## **Final Environmental Impact Report for the Del Mar City Hall/Town Hall Project Del Mar, California / SCH #2015051067**

# Del Mar City Hall/Town Hall Project Final Environmental Impact Report

## Errata

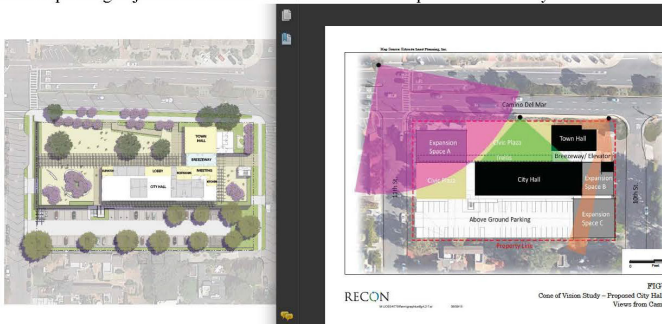
Expansion area B is within 100 feet of the bedroom window of 220 10<sup>th</sup> and at a similar elevation to the bedroom creating a privacy, light and noise concern. A majority of the windows of the city office building are also within 100ft and at a similar elevation to our bedroom windows. Unlike the office building, the expansion area B is likely to be used at night when privacy and quiet are most valued. Even with an 8 ft sound wall the privacy impacts on the outdoor patio and bedroom at 220 10<sup>th</sup> would be significant.

O-3 See response to comment O-2 above regarding project design options considered and analyzed within the Final EIR.

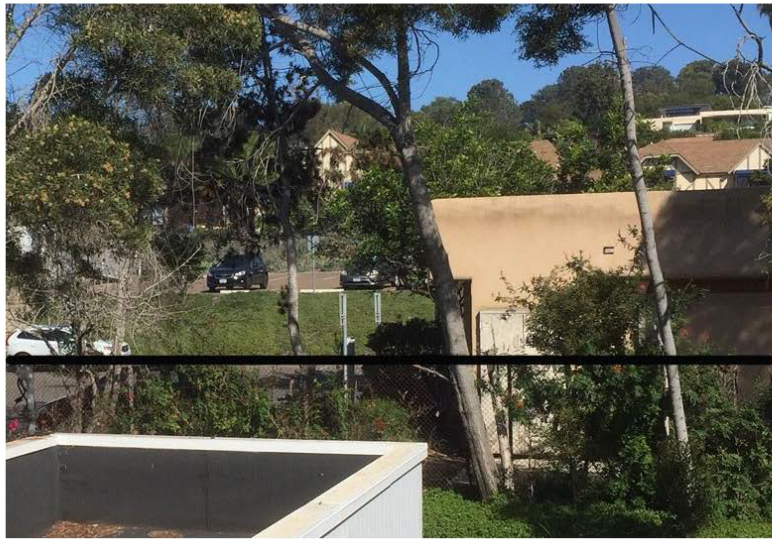
The parking is in close proximity to the house at 220 10<sup>th</sup> Street. This is a picture taken from the 10ft setback line from a proposed parking spot. Bedroom window is above the blue tarp.

Proximity of outdoor parking will mean noise impacting the outdoor and indoor areas of our home. The proposed parking is closer to the adjacent residences than the existing configuration. The picture below shows the proposed parking configuration – the fence is at the setback.

O-4 The parking shown and analyzed in the EIR is from a conceptual site plan and is going through refinement within a concurrent design review process. Refinements to the conceptual site plan as illustrated in Figure 3-2 and described in Chapter 3.0, Project Description, have been reviewed in the Final EIR. There has been no considerable change in the design of the surface parking lot that would be substantially different from that analyzed within the Draft EIR and therefore, no further study is required.
